**GLENORCHY PLANNING AUTHORITY MEETING**  
**AGENDA**  
**MONDAY, 2 OCTOBER 2023**

## **5. PROPOSED USE AND DEVELOPMENT - STAGED MULTIPLE DWELLINGS (ONE EXISTING AND SEVEN PROPOSED) - 2 MOORE PARK DRIVE GLENORCHY**

<b>Application No.:</b>	<b>PLN-22-403</b>
<b>Applicant:</b>	<b>Emmanuel Dellas Pty Ltd</b>
<b>Owner:</b>	<b>Tosajo Corporation Pty Ltd</b>
<b>Zone:</b>	<b>General Residential Zone</b>
<b>Use Class</b>	<b>Residential</b>
<b>Application Status:</b>	<b>Discretionary</b>
<b>Discretions:</b>	<b>8.4.2 (A1) (A3) Setbacks and building envelopes for all dwellings</b> <b>8.4.3 (A1) Site coverage and private open space.</b> <b>8.4.6 (A1) and (A3) Privacy for all dwellings</b> <b>C2.6.5 (A1.1) Pedestrian access</b> <b>C3.5.1 (A1) Traffic generation at a vehicle crossing, level crossing or new junction</b> <b>C9.5.2 (A1) Sensitive use within an attenuation area.</b>  (The proposal meets all other applicable standards as demonstrated in the attached appendices)

**Figure 4.** Elevation of Unit 4 as visible from Moore Park Drive, where only the lower level portico intrudes upon the frontage setback.

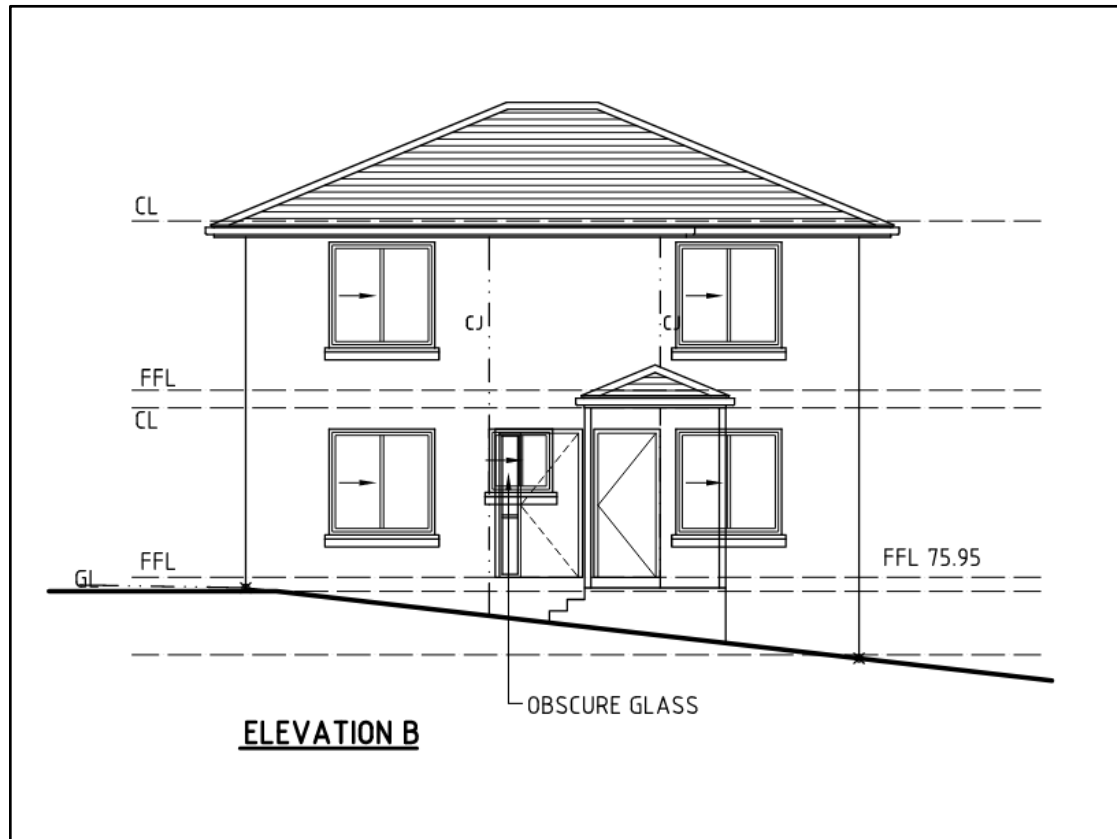
The proposed setback of 3.5m for the covered entrance of the dwelling is a minor deviation from the Acceptable Solution, noting the bulk of the dwelling is setback at 4.5m. The proposal is considered to be entirely within the expectation of residential development in the General Residential Zone and so is compatible irrespective of this protrusion and for that reason is considered to comply.

**Figure 5.** Elevation showing building envelope relative to bulk of dwelling (black) and building envelope relative to the roofed deck (blue).

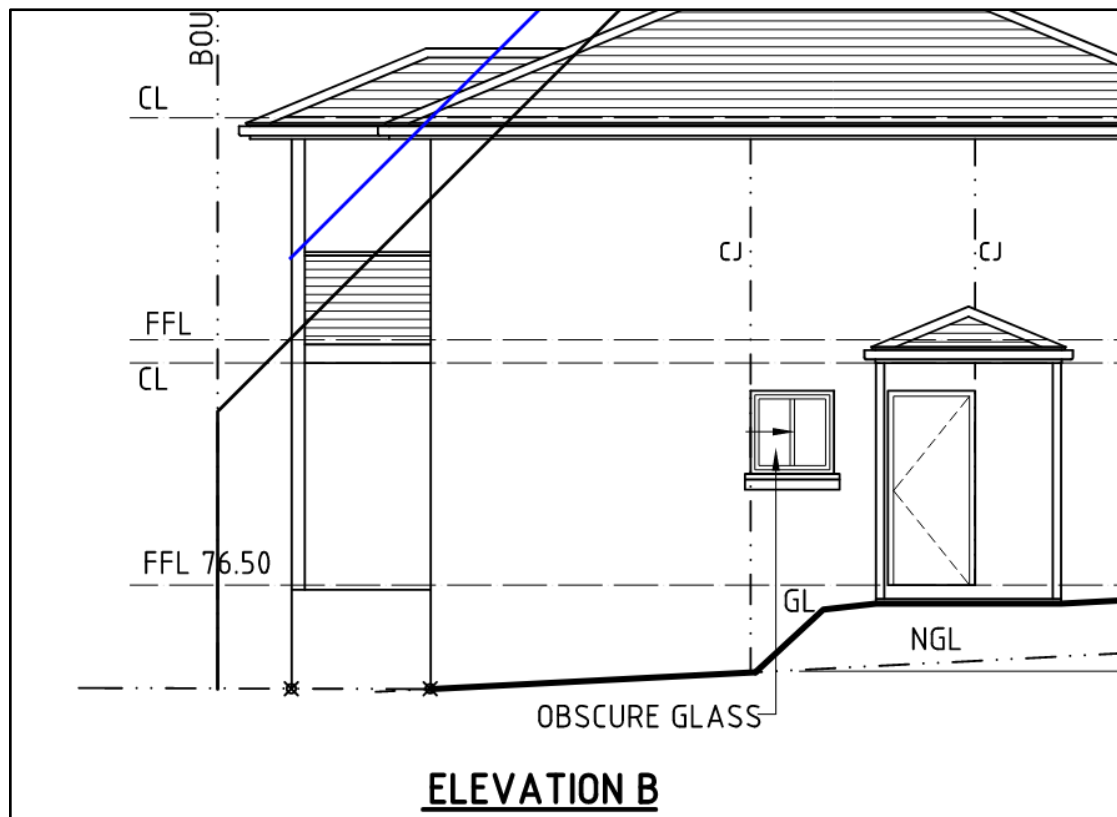
Unit 4 has a portico to the fore of the dwelling, and Unit 3 has a deck which is roofed and protrudes to a moderate degree from the building envelope (see figure 5). The proposal is therefore reliant on the performance criteria which require:

For Unit 3, the proposed deck protrudes moderately from the building envelope. There is no specific need for the deck, tending to its reasonableness as a visual impact being questionable. The deck does not contribute to the private open space of the dwelling.

On balance, and appreciating the design also causes for additional discretionary consideration under clause 8.4.6 Privacy for all dwellings, it is a recommended condition of approval that prior to the submission of building approval documents, plans be submitted which do not include the deck.

Subject to this recommended condition, the proposal complies with this standard.

**Figure 7.** Graphic indicating the measured height above natural ground level for that part of the landing which is highest above natural ground level.

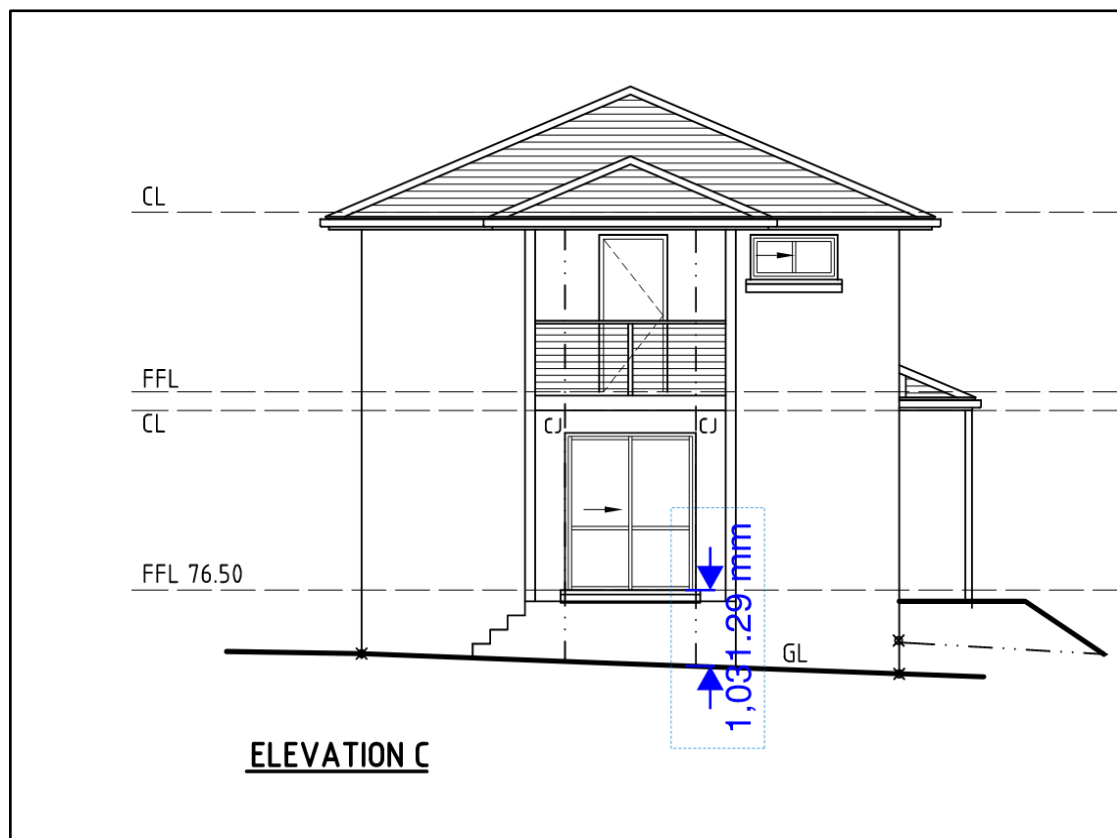
With respect to the landing being measured at its greatest 1.03m above natural ground level; though not complying with the acceptable solution, it is considered to screen that portion of the landing which exceeds 1m would be nonsensical owing to its minor width. The proposal therefore is able to proceed as made, appreciating it is designed to the largest degree to minimise overlooking, being predominately at or less than 1m above natural ground level.

The proposal is considered to comply.

**Figure 8.** Extract of site plan showing those windows within 2.5m of the edge of the kerb to internal circulation areas, or parking spaces.

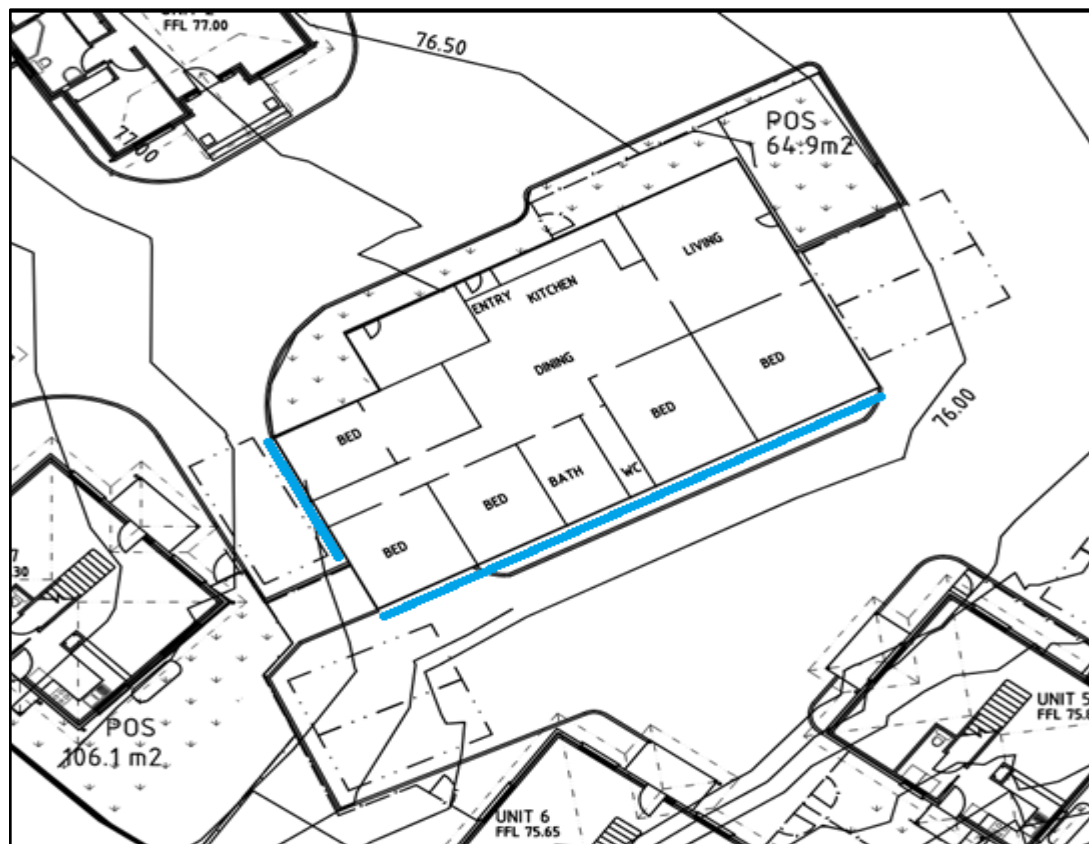
The parking spaces and circulation areas, relative to the existing dwelling (Unit 8) are not in accordance with the acceptable solution (see Figure 8).

This condition affords the ability to both extend the separation of the kerb from the bedroom windows to comply with the acceptable solution, or to provide screening for any portion where distance to the edge of the kerb cannot be increased without compromising parking and turning areas.

Subject to this recommended condition the proposal is considered to comply.

**Figure 10.** Stormwater concept design.

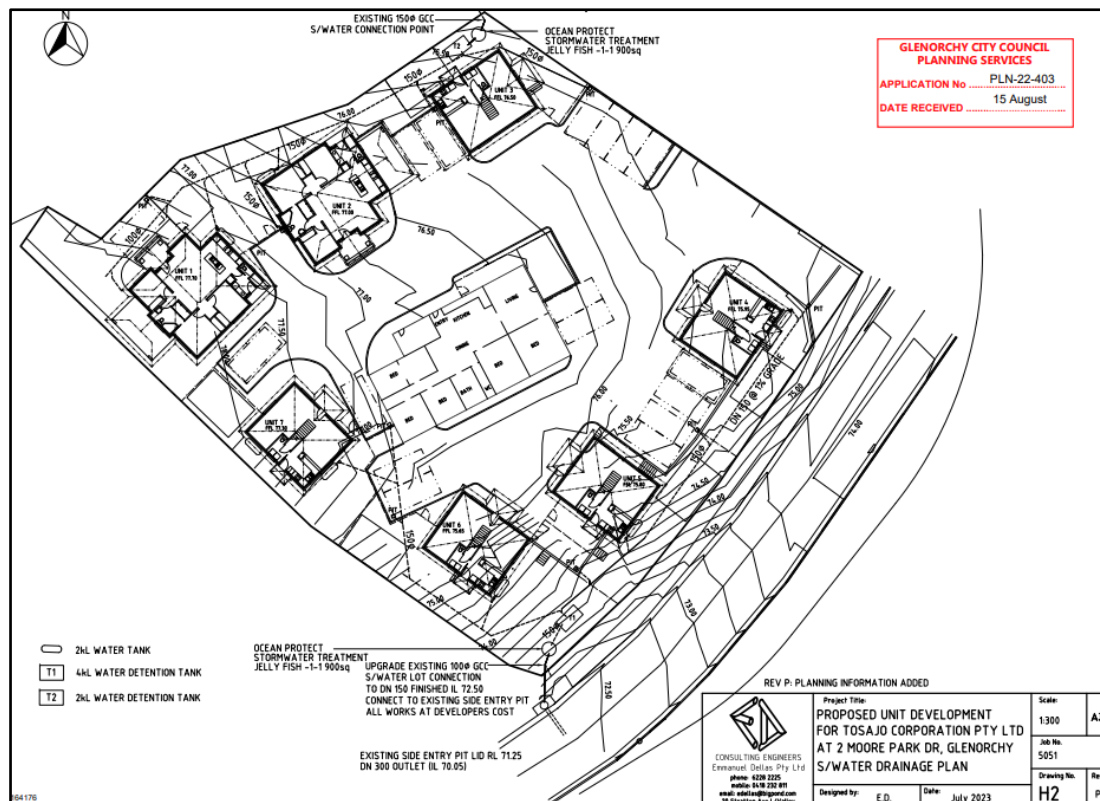
Runoff from the development is proposed to be collected and drained to the on-site stormwater detention system and the stormwater treatment elements prior to discharged to both stormwater connections, as see in the figure below.

Therefore, the General Manager's consent to interfere with stormwater infrastructure can be granted.

Figure 6: Flood Prone Areas Hazard Code - theList

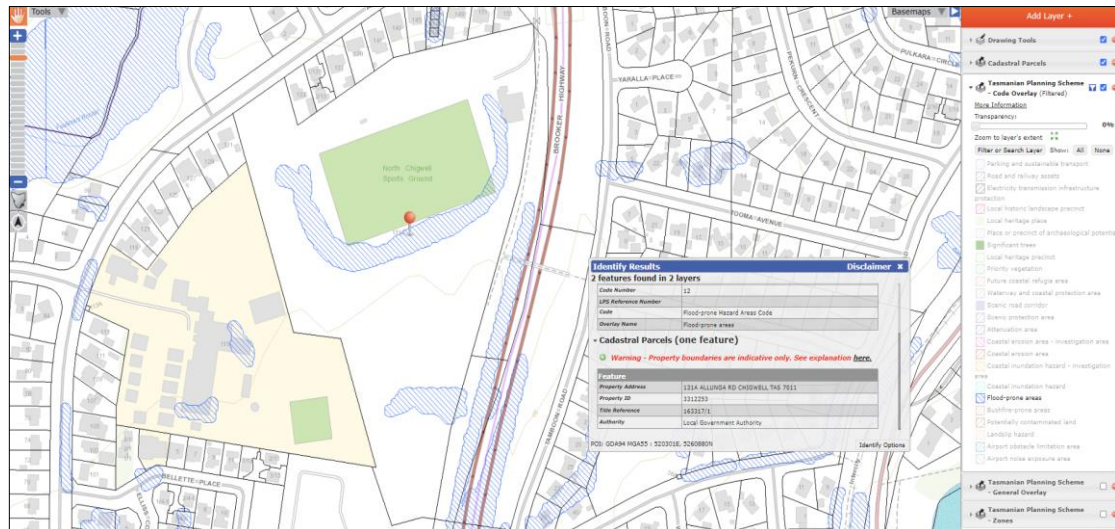
The Flood-Prone Areas Hazard Code applies to the proposed development as a small section of the development and works are located within the overlay. The overlay is shown in Figure 5 below.

There is no acceptable solution. Therefore, the proposal relies on performance criteria as follows:

Figure 7: Plan of Proposed Development

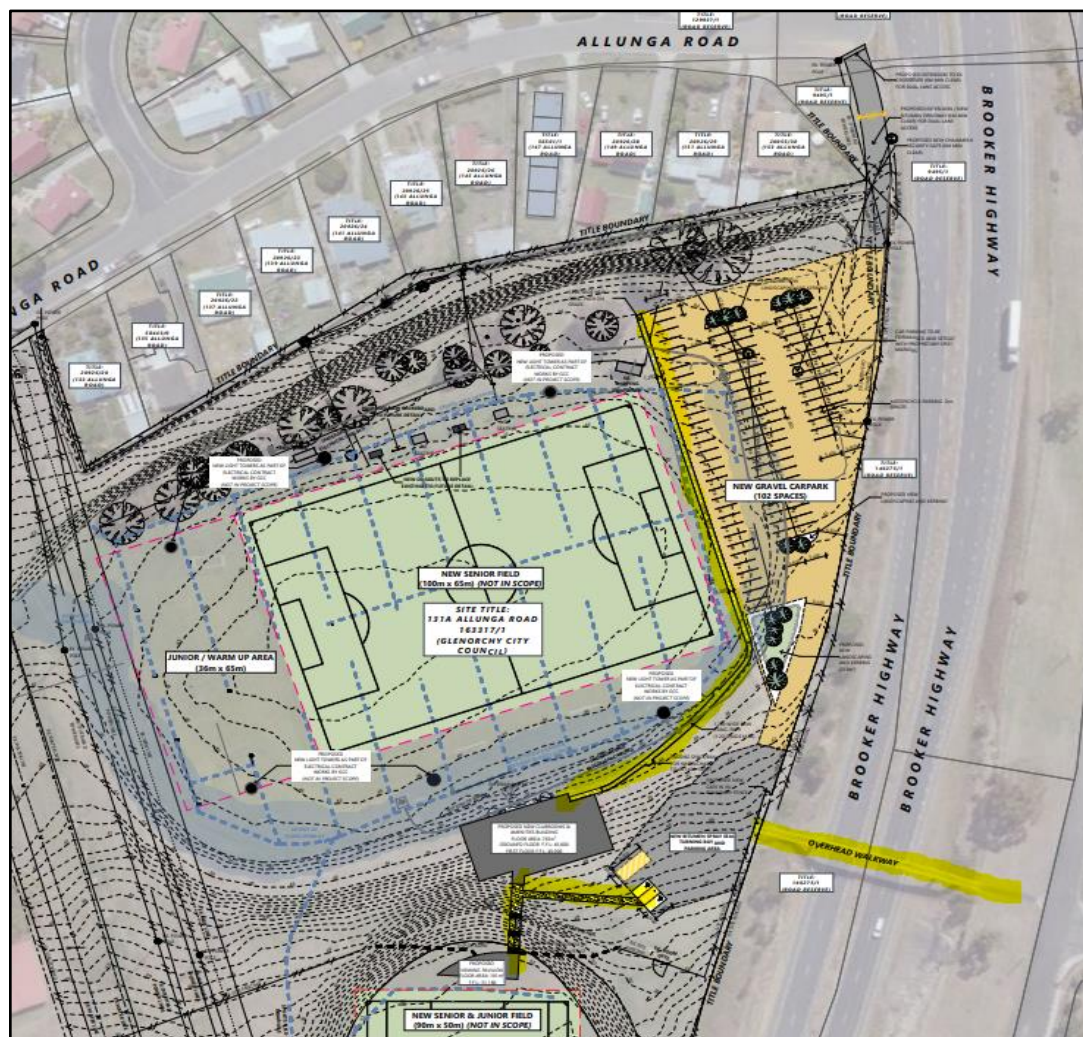
The layout of the driveway access, car park and pedestrian paths are shown in the image below, with the pedestrian facilities highlighted in yellow. This image is from the site plan A001-P03 by ARTAS Architects.

The TIA undertook a survey on Saturday 21 August 2021 between 11 and noon, at the soccer ground and Allunga Road fronting the sports ground. It found that there was a maximum of 60 vehicles parked at any one time within the sports ground and a maximum of 32 vehicles parked at any one time in Allunga Road. The increase and improvements in parking within the site should reduce parking in Allunga Road.

Figure 8: Extent of 1% AEP flood impacts (blue shading) near the proposed building (external Concrete walkway and ramp)

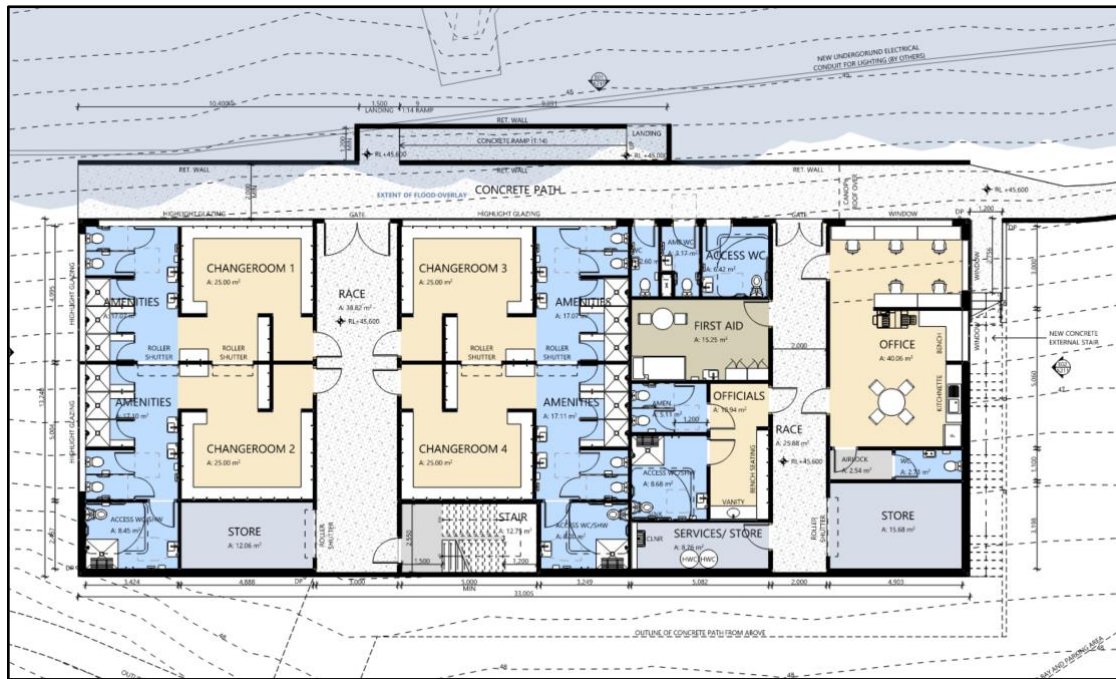
This land is not subjected to any major overland flow paths or high-risk flooding. Although a small portion of the proposed clubroom building footprint (external walkway access ramp) is shown to be impacted with localised ponding during a 1% AEP (Annual Exceedance of Probability) flood event.

Building floor heights have been set out 300mm higher than the localised flood heights and the building use is not identified as critical or vulnerable infrastructure. Furthermore, the design has proposed drainage improvements to the outer perimeter of the building such as channel grates, retaining wall to the ramp that would minimise any erosion impacts the building.
